To
cc
bcc
Subject Fw: Draft Environmental Impact Statement

To "swcorridor@co.hennepin.mn.us"
 <swcorridor@co.hennepin.mn.us>
 cc
 bcc
 Subject DEIS Comment - Wooddale Ave Intersection Safety

I would like to submit comments in response to the SOUTHWEST TRANSITWAY DRAFT ENVIRONMENTAL IMPACT STATEMENT. As a civil engineer and a resident of St. Louis Park, I support the Southwest Corridor light rail in my neighborhood. However, I am concerned about the safety of motorists and pedestrians at the Wooddale Ave intersection, which is planned to be at-grade. I see the construction of the light rail as an opportunity to improve safety for pedestrians and motorists.

Figure 2 – Measurement of vertical direction vibration with a maximum level of 84 VdB.

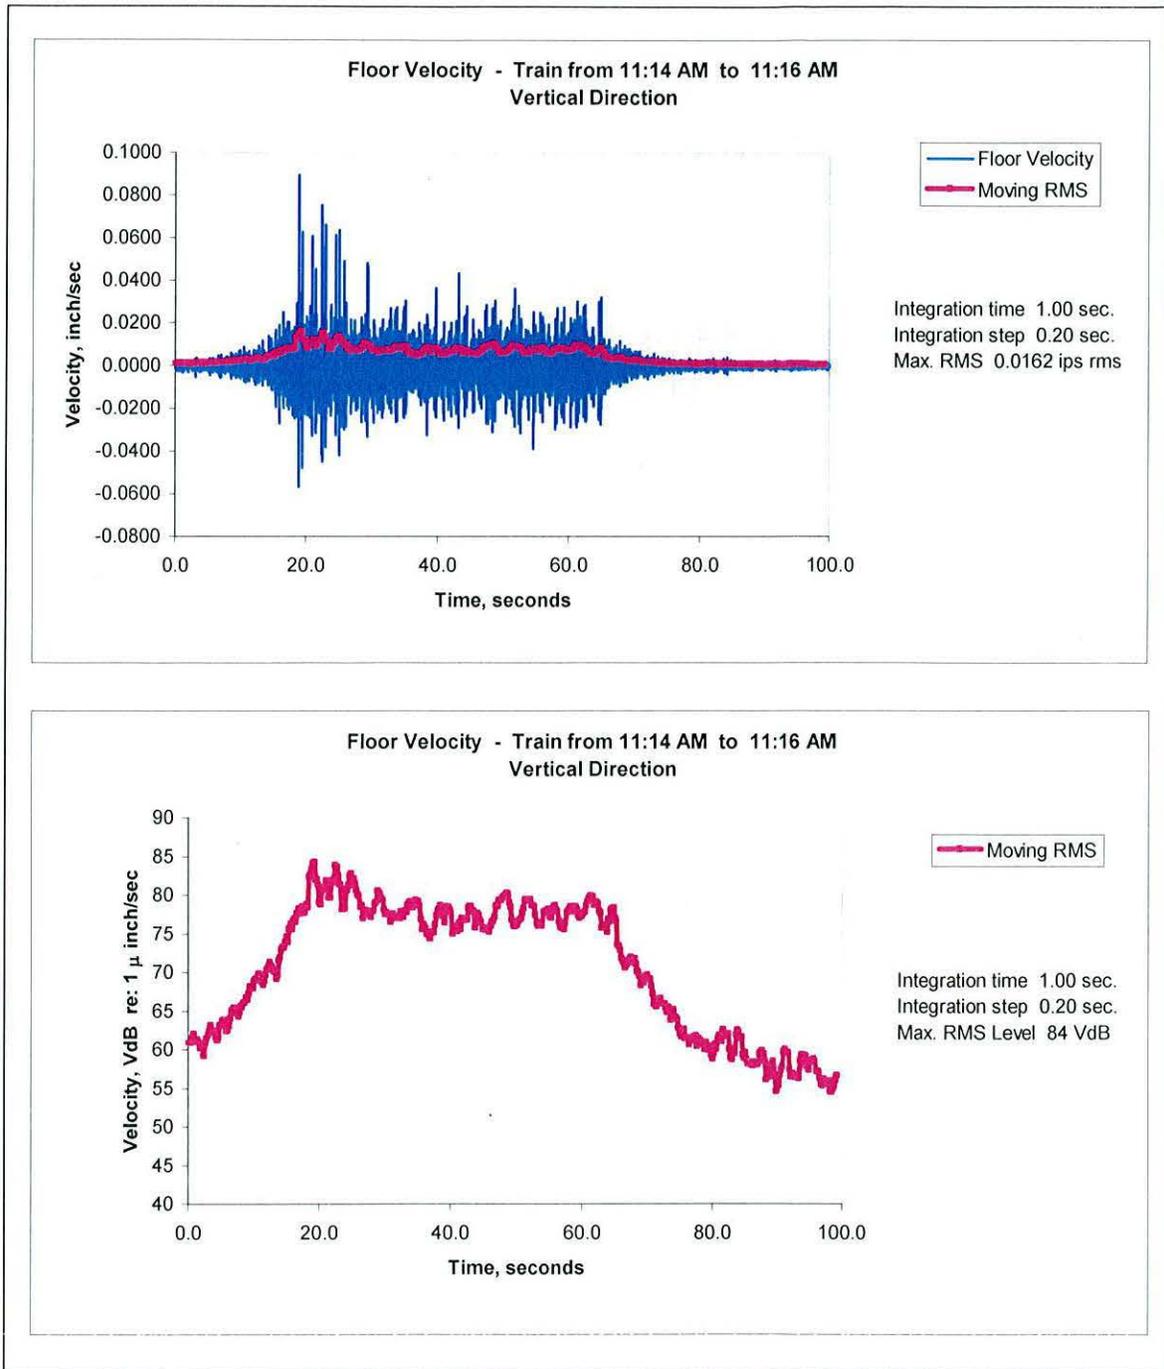
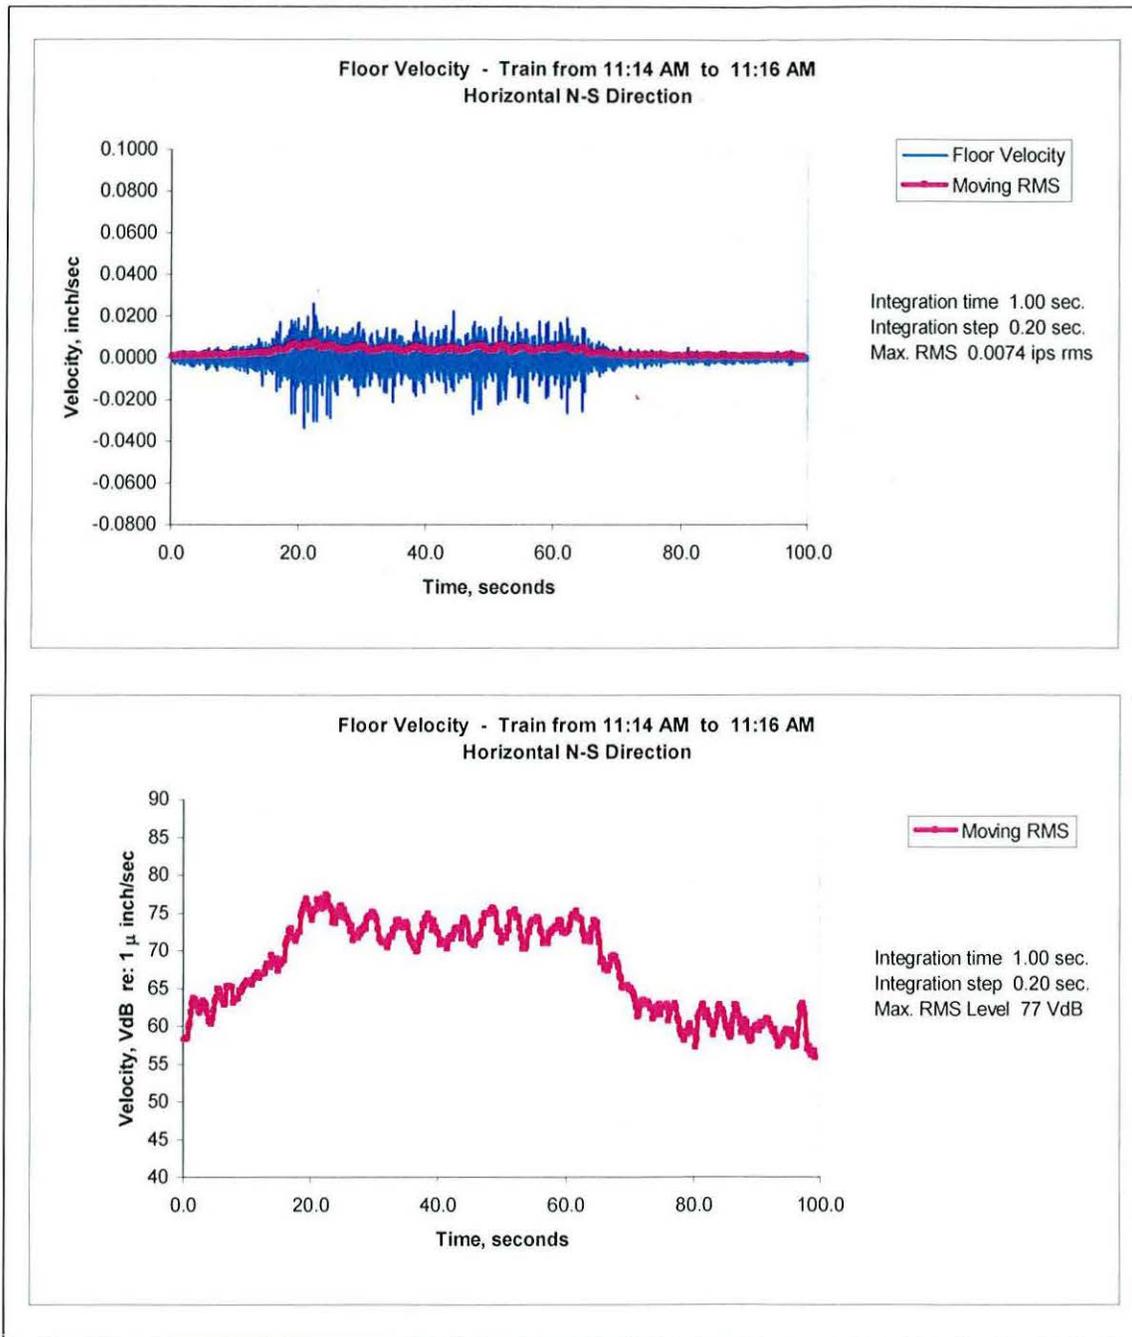
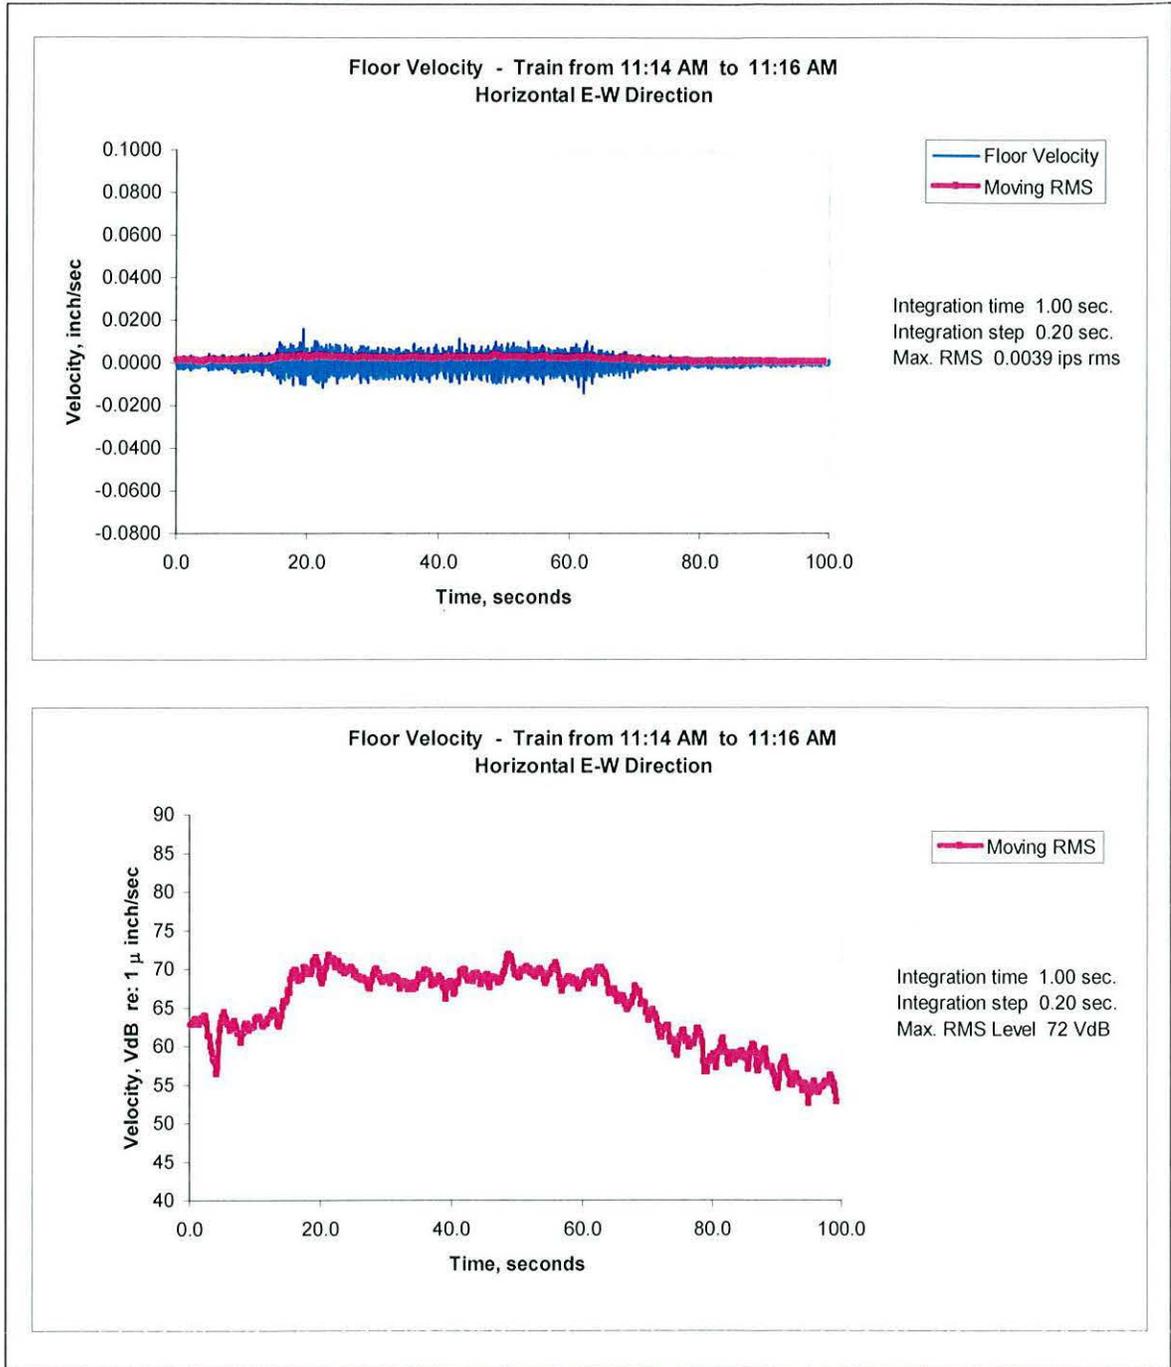
Attached you will find additional vibration analysis done by ESI that shows a remarkable difference from measurements taken by Kimley-Horn. This shows that vibrations exceed federal guidelines today. I would like all of this information included in the record as part of the formal comment period on the EAW for the MN&S Freight Rail Study in St. Louis Park. There has been no vibration mitigation proposed, and in fact, vibrations are expected to increase dramatically in both frequency and severity. Should this reroute happen without a REDUCTION of vibration to levels within federal guidelines, you will be facing costs to purchase and relocate many businesses, buildings and homes at a cost that has not been considered as a part of the EAW analysis.

Two trains passed the building on April 13th. Figure 2, 3 and 4 present the results for the first train which passed between 11:14 AM and 11:16 AM. The maximum rms level was 84 VdB in the vertical direction. The second train had a similar vibration level.

A noise and vibration report is being prepared to address this complex question and will be part of the Environmental Assessment Worksheet (EAW). It will provide more clarity on the methodology, impacts and mitigation.

Exhibit 3. Vibration Measurement Results and Projections

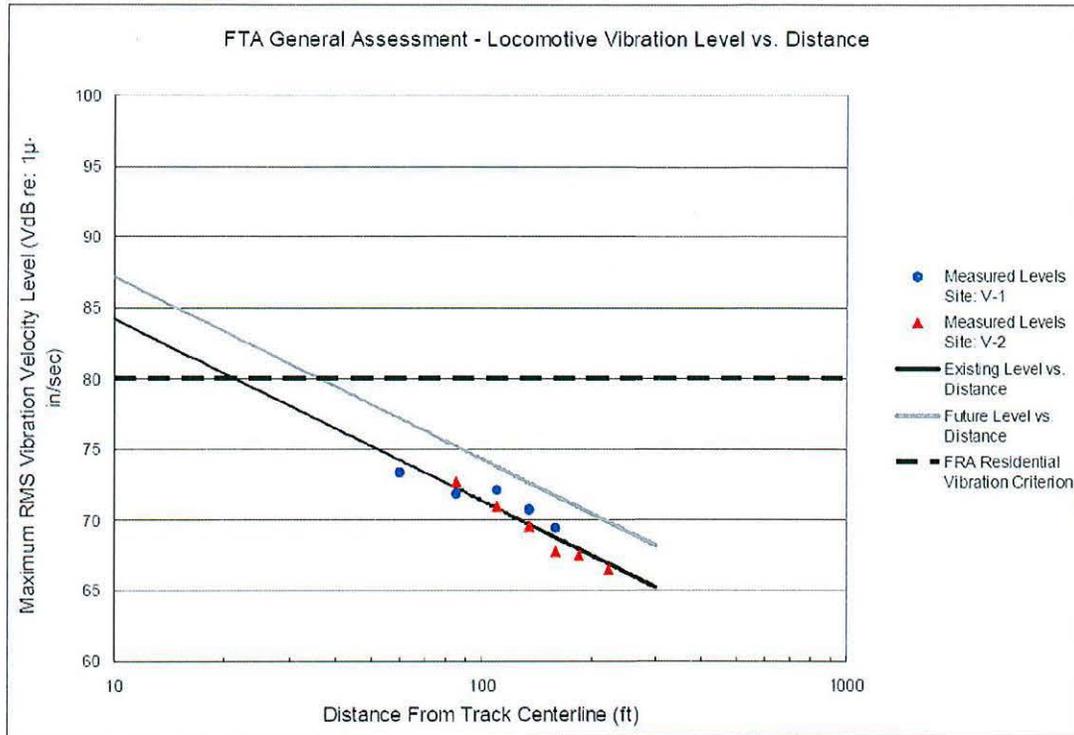
The locations of the existing vibration measurements are shown in **Figure 10** and the results of the existing vibration measurements are shown in **Exhibit 3** below, along with projections of future vibration levels from trains with the higher speeds and the continuously welded rail. The results indicate that for the existing trains, locomotive vibration levels of 80 VdB (the criterion for vibration impact for infrequent events) would be experienced up to 30 feet from the tracks. For existing rail cars, which typically have vibration levels 5-8 VdB lower than locomotives, vibration levels of 75 VdB (the criterion for vibration impact for occasional events) would also be experienced up to 30 feet from the tracks.

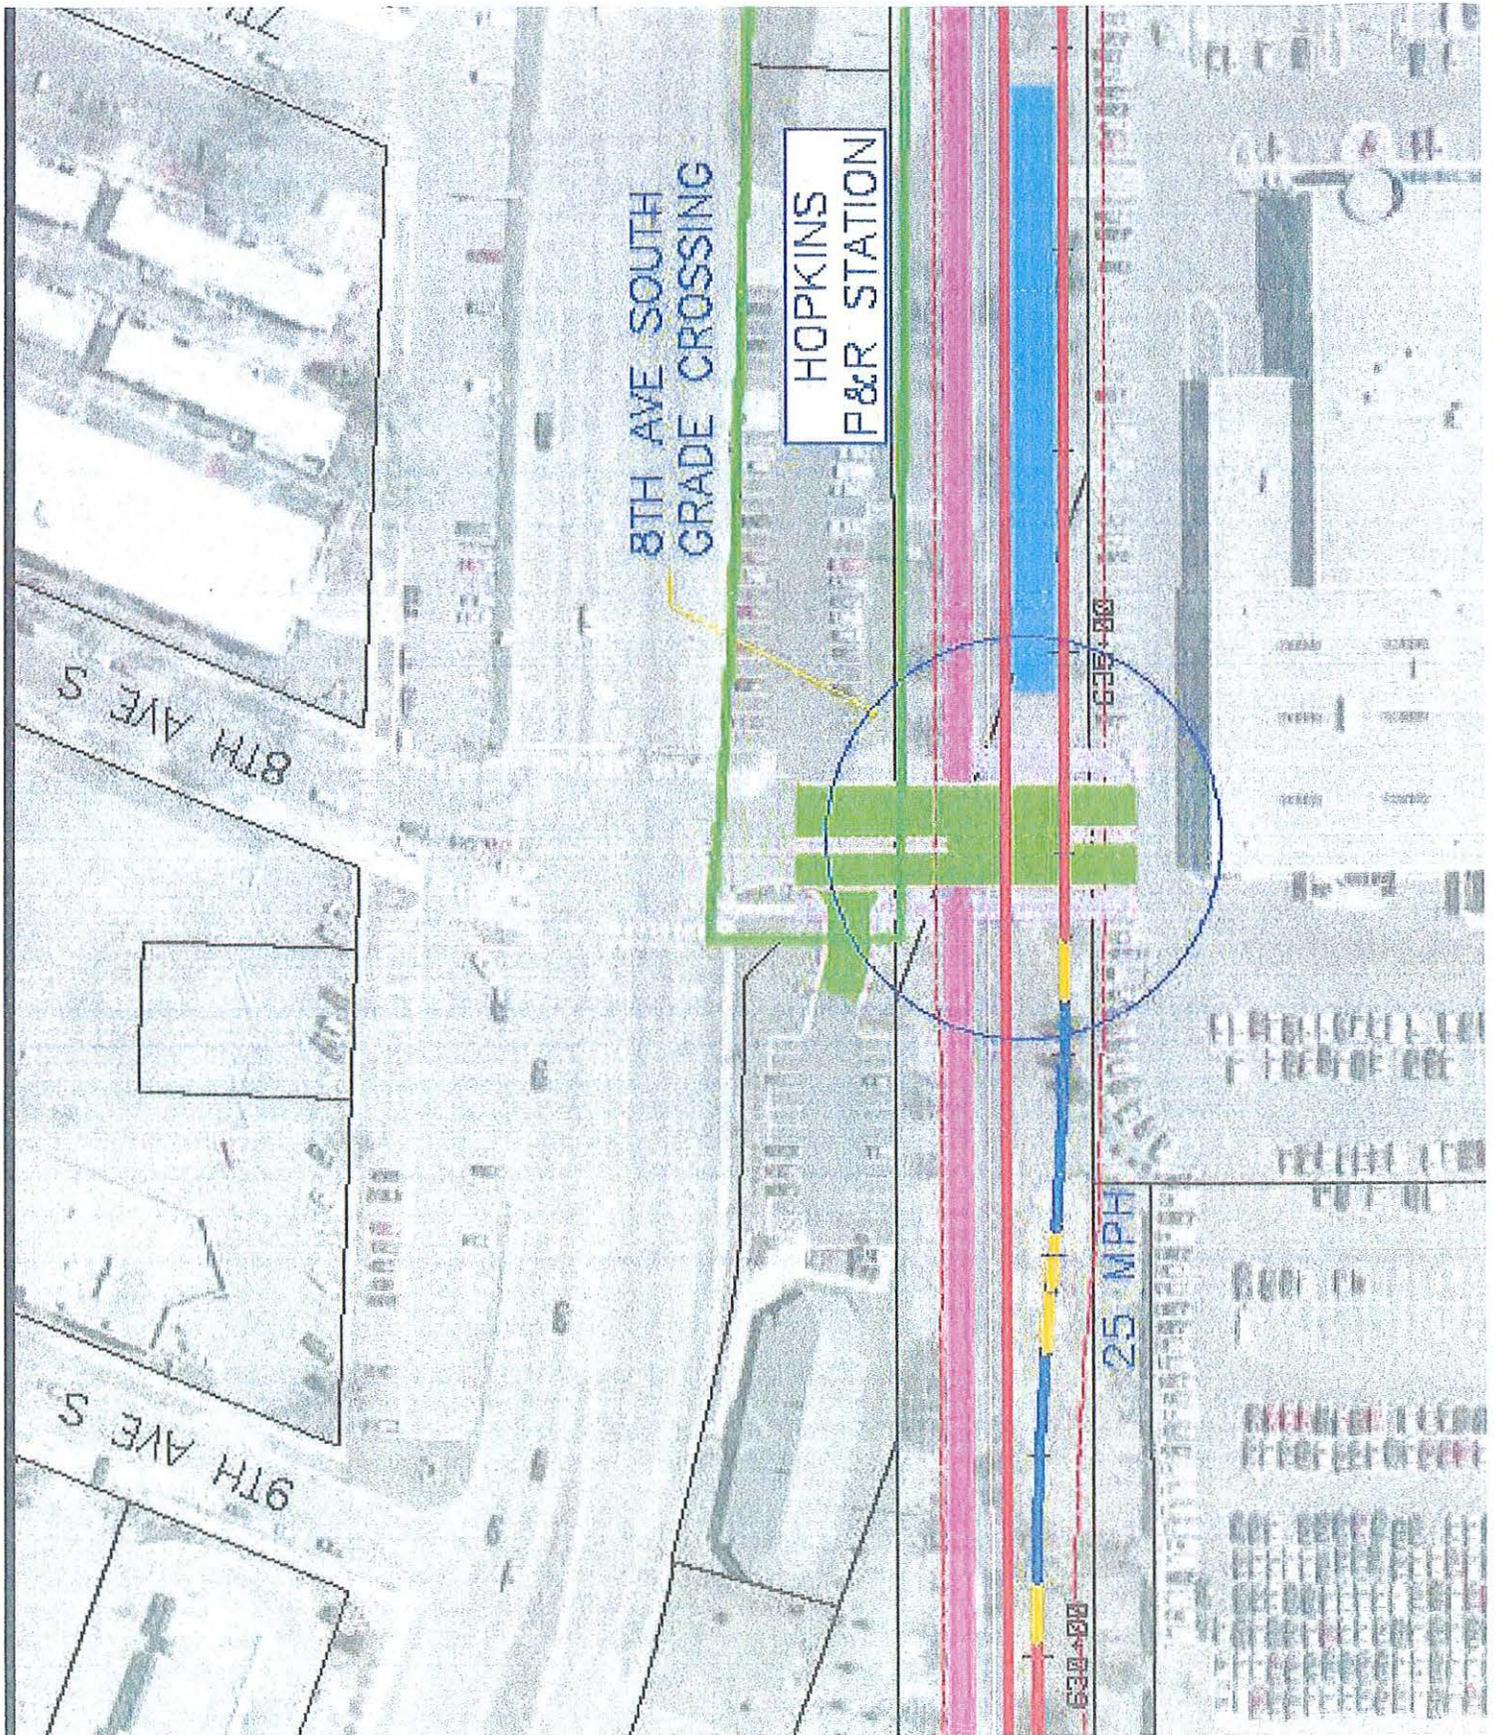
Referring to the attached drawing, my question is what is the meaning of the pink line in the middle of the 8th Avenue extension south of Excelsior Blvd.? If that pink line is intended to suggest a raised center island, I need to immediately indicate that the portion of the pink line across our driveway is a serious problem. Looking at the drawing, one obvious problem is that users of our property would have no legal means of exiting from the parking lot. Such users would have to turn south and trespass on the Hopkins Honda property in order to exit to Excelsior Blvd. Furthermore, such a restriction on exiting from our property would violate an easement agreement we executed with the City, which assures that users of our property will have direct access to Excelsior Blvd. for both ingress and egress purposes via the southerly extension of 8th Avenue.

Please clarify the intention of the referenced pink line in the attached drawing. If this is meant to suggest a raised center island, please indicate how you intend to proceed to eliminate the raised island blocking our driveway. It seems that one option would be to begin the raised island on the south side of our driveway and utilize pavement striping from there north to Excelsior Blvd.

In response to your technical question about the pink line, it refers to the reconstructed interim use bike trail that is currently housed within the HCRRA right-of-way.
